# CITY OF MADISON

# Proposed Conditional Use

Project Name: Texas Roadhouse

Project Texas Roadhouse Madison, WI  
Project # 20050922.2  
Re Resubmittal: Urban Design Review

**WI-50922A6**  
 SHEET 1 of 2

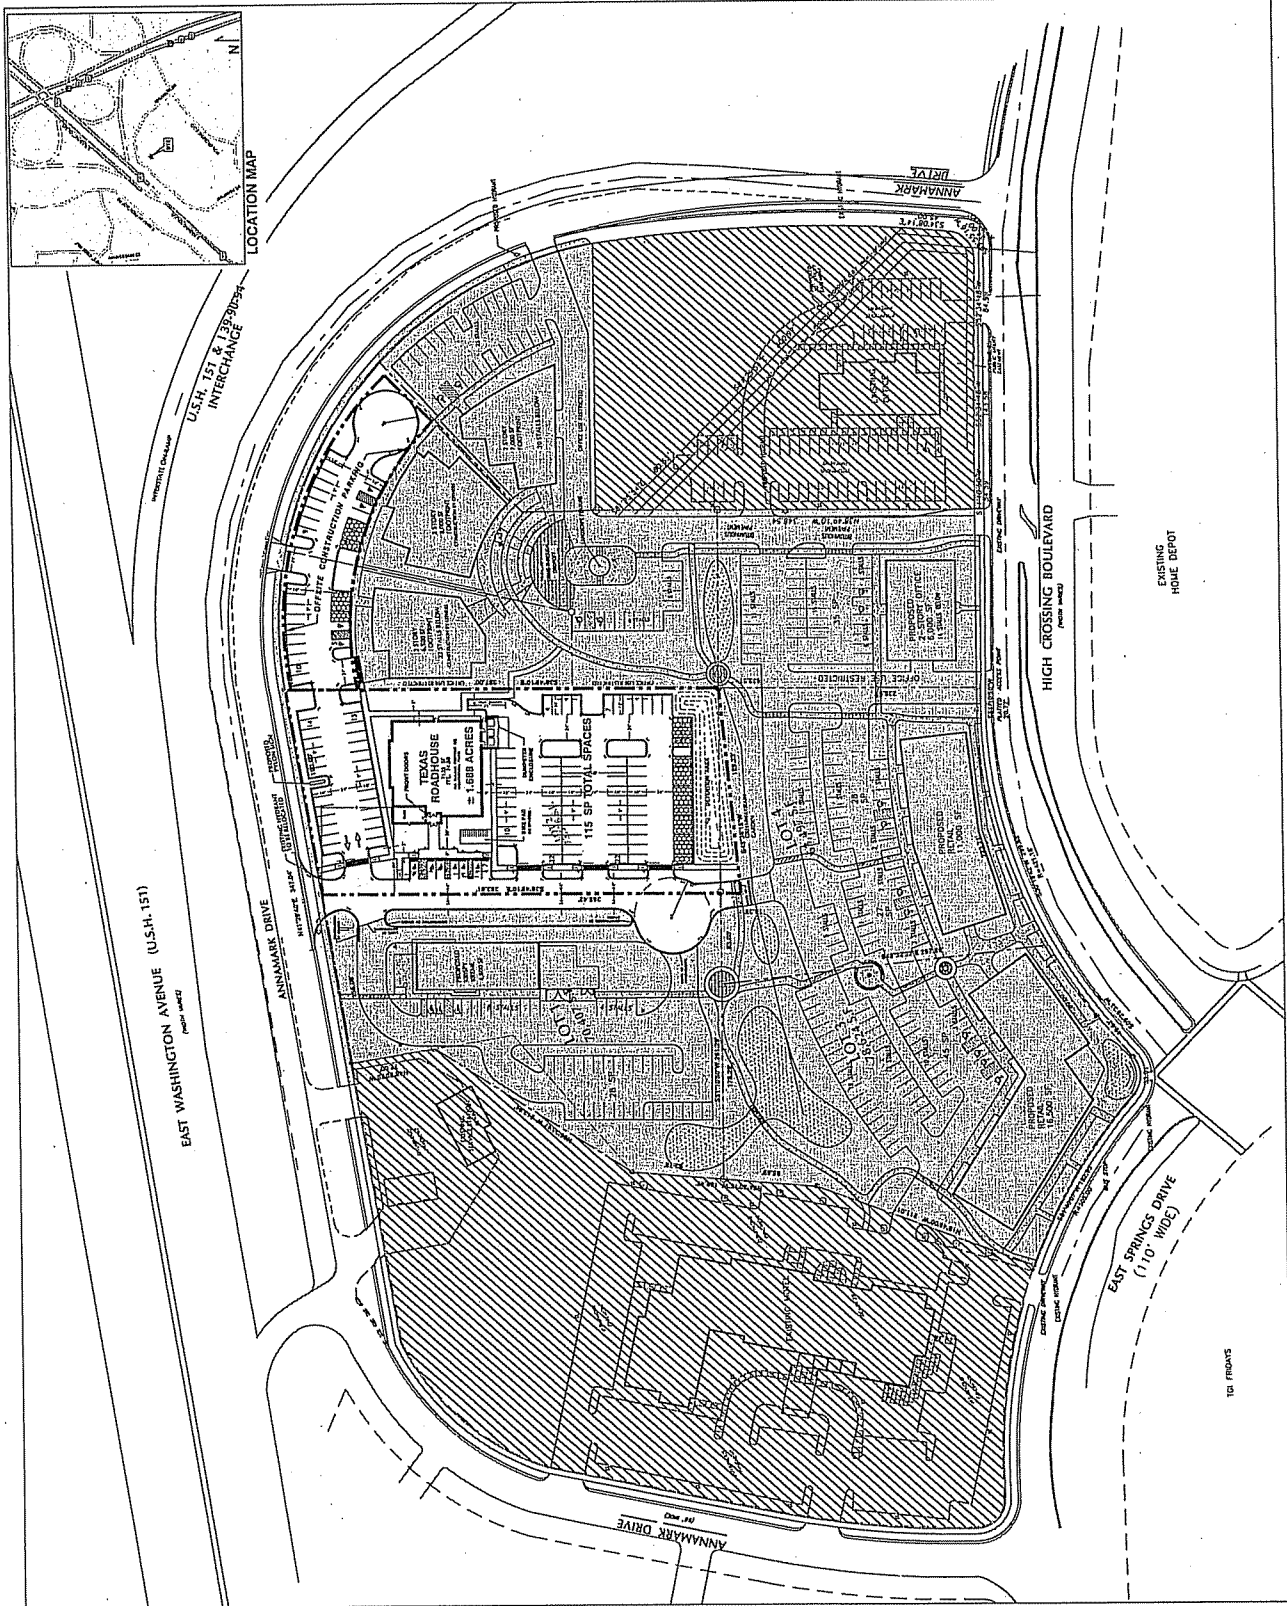
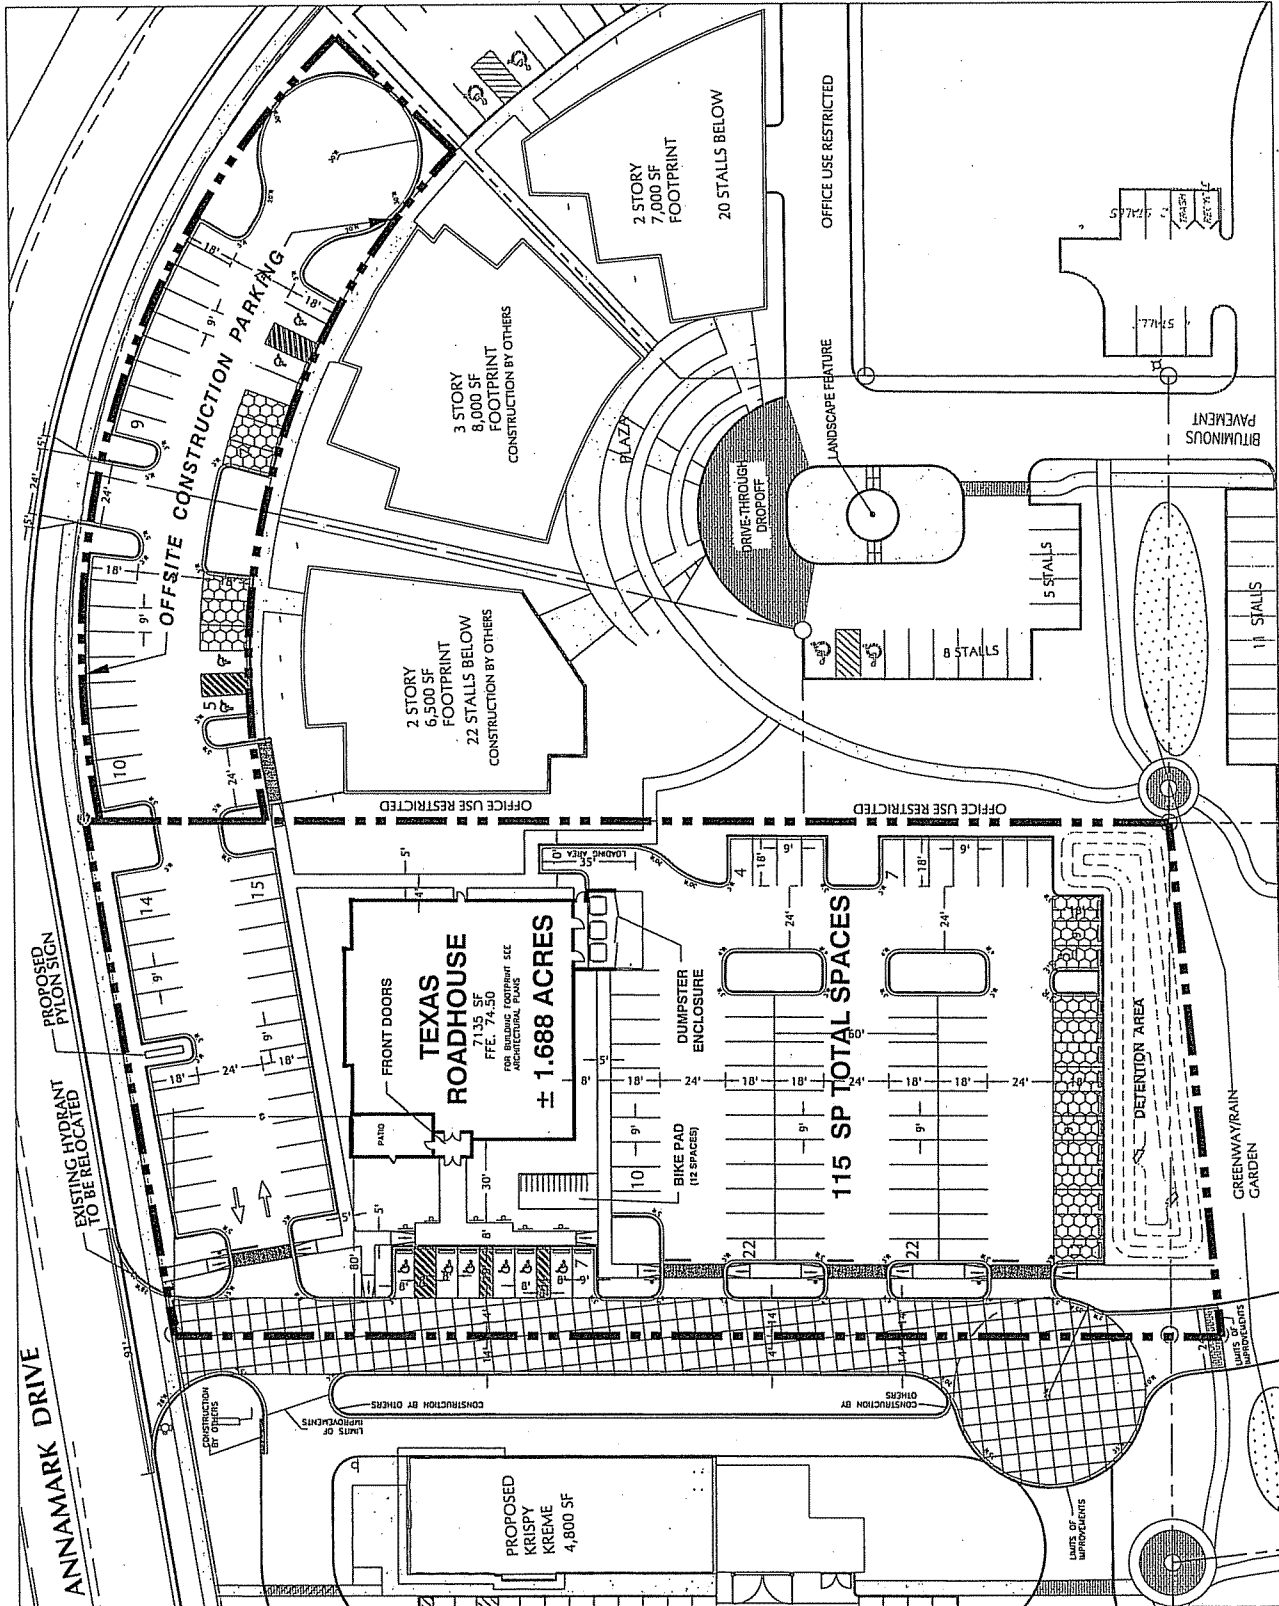
5. The site plan has been revised to add permeable pavement for the fourteen (14) parking stalls by the detention area and six (6) spaces in the off-site parking area.

**L-1.0**

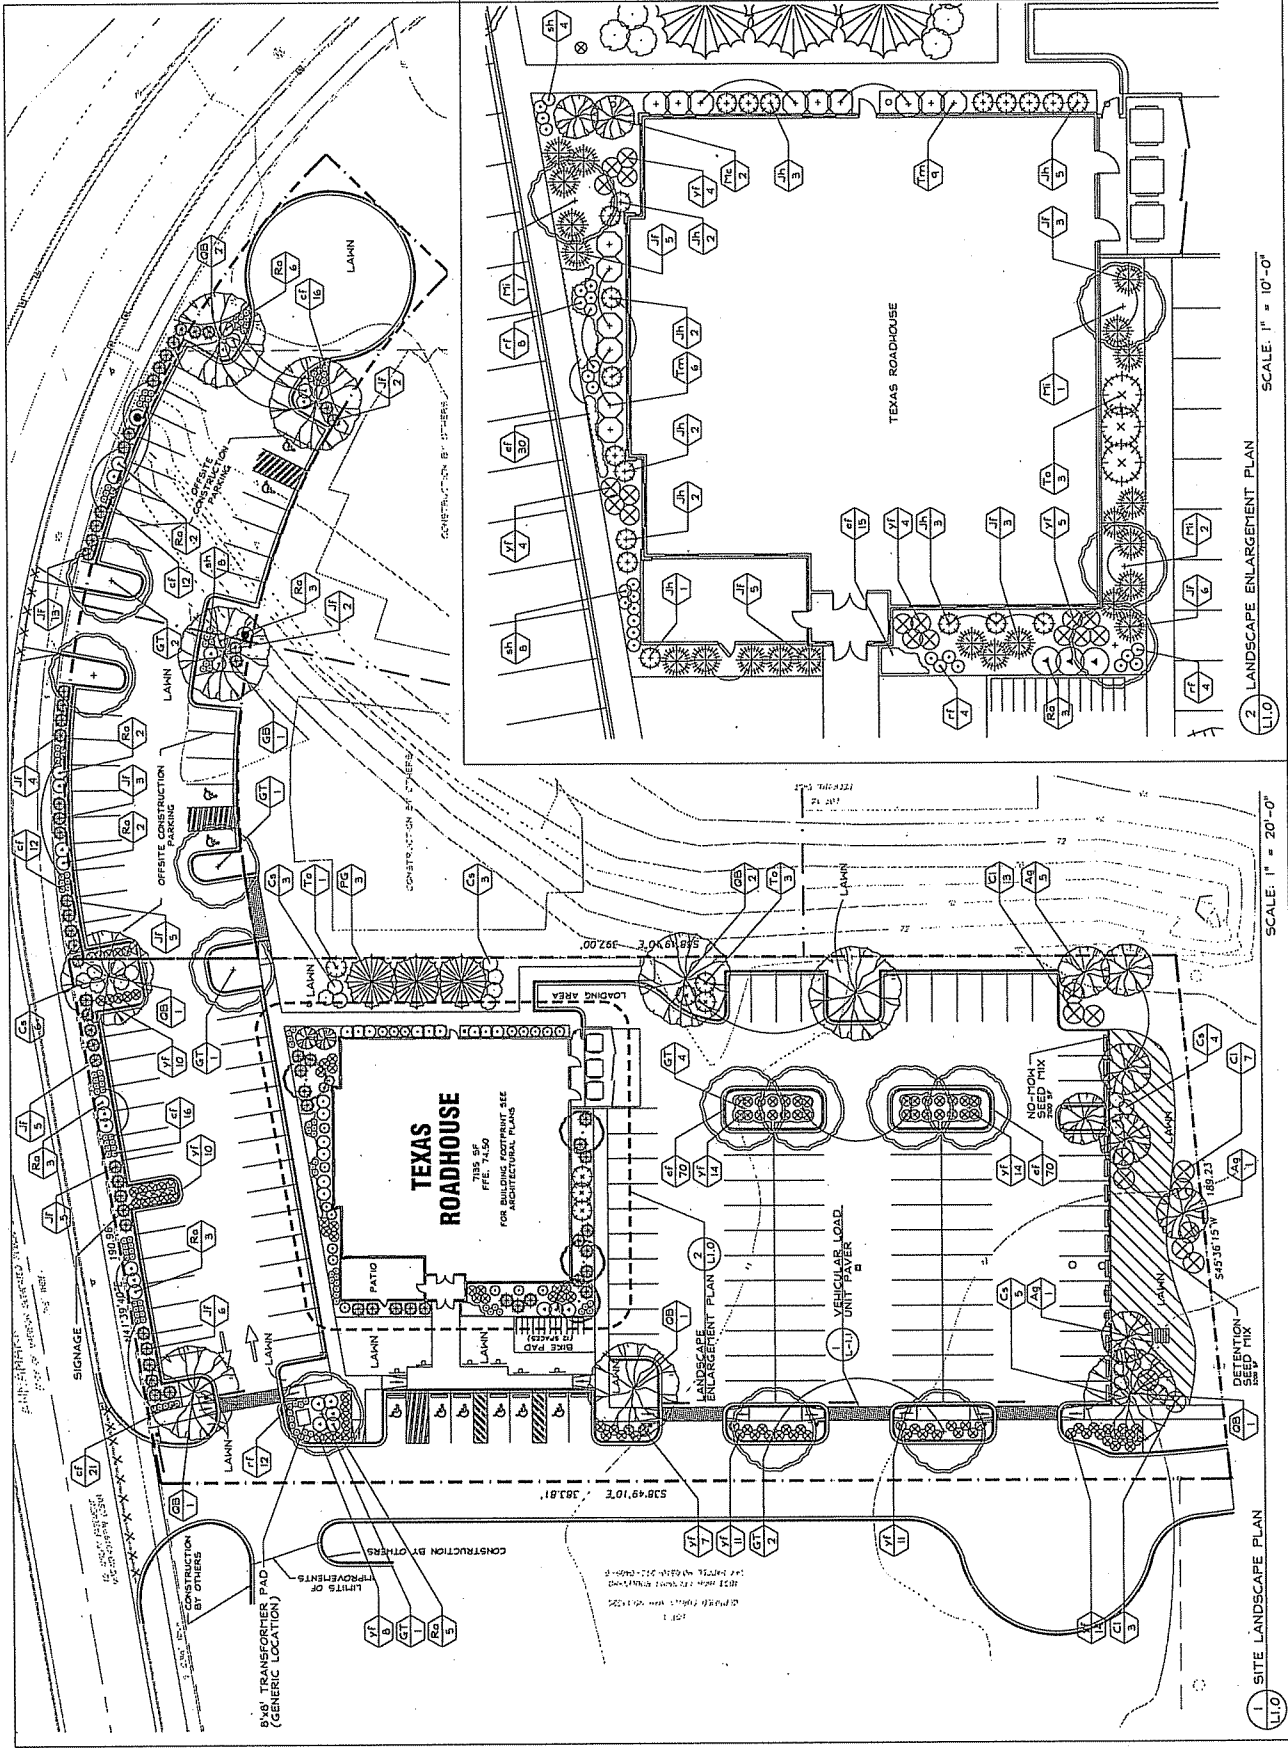
6. The landscape plan has been revised to show additional plant material in the off-site parking area and a "detention mix" proposed in the detention basin area at the southern end of the site.

**FRONT (NORTH) ELEVATION**

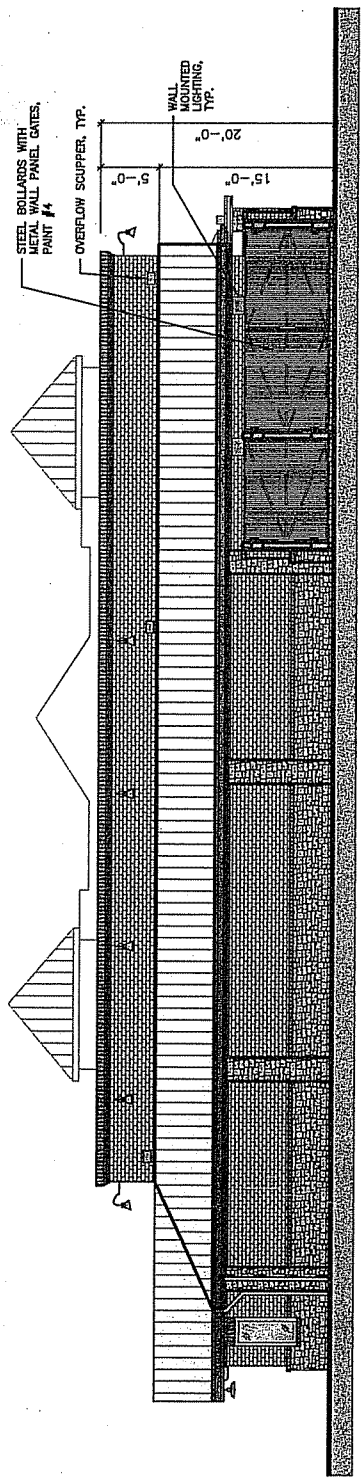
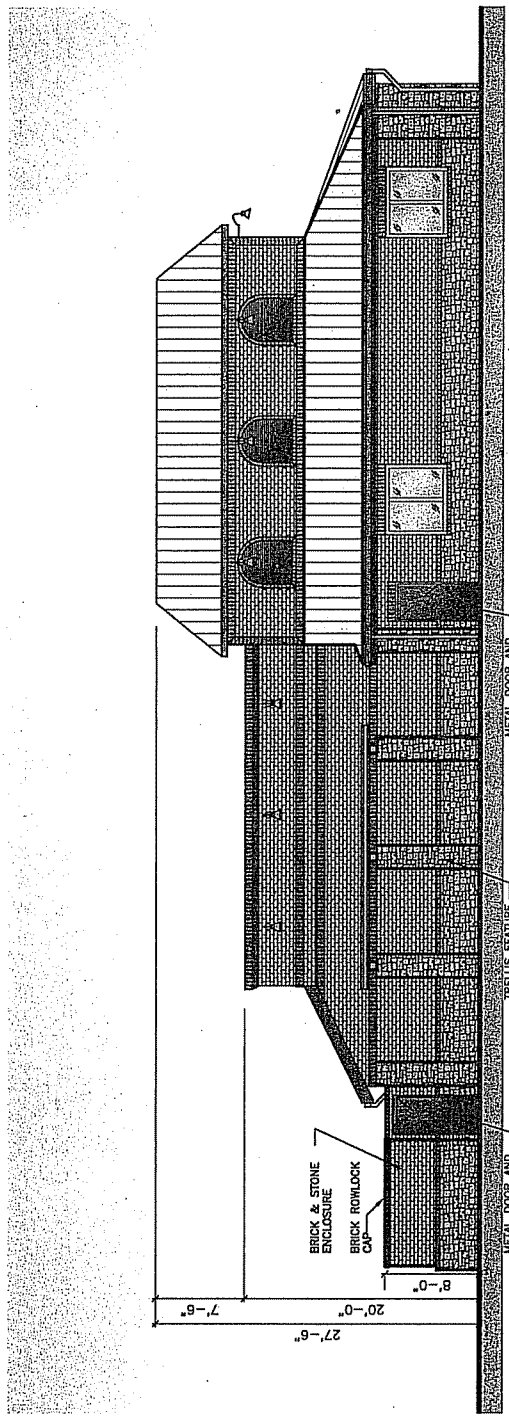
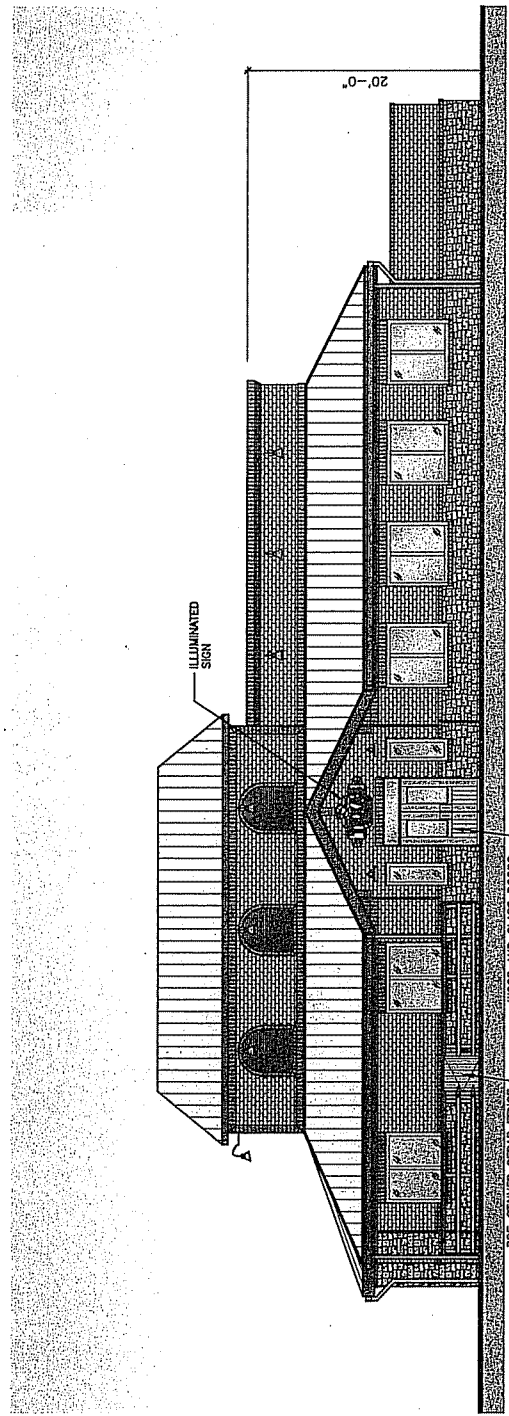
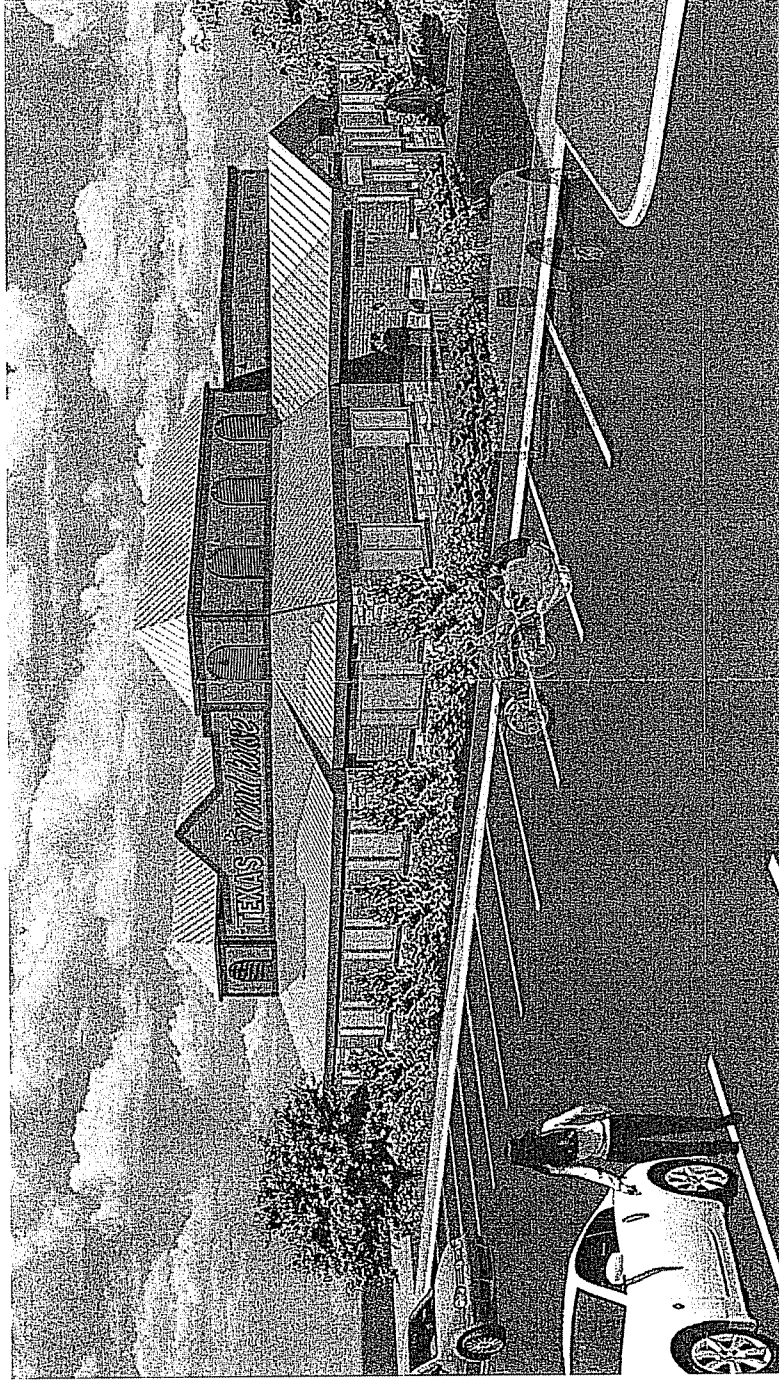
7. The architectural elevations have been revised to:
    - Remove the U.S. and State of Texas flags.
    - Incorporate full height brick with stone wainscoting.

- Incorporate architectural detailing such as accent banding, soldier courses and a trellis type structure along the east elevation.
    - Incorporate additional casements within the windows along the west elevation.
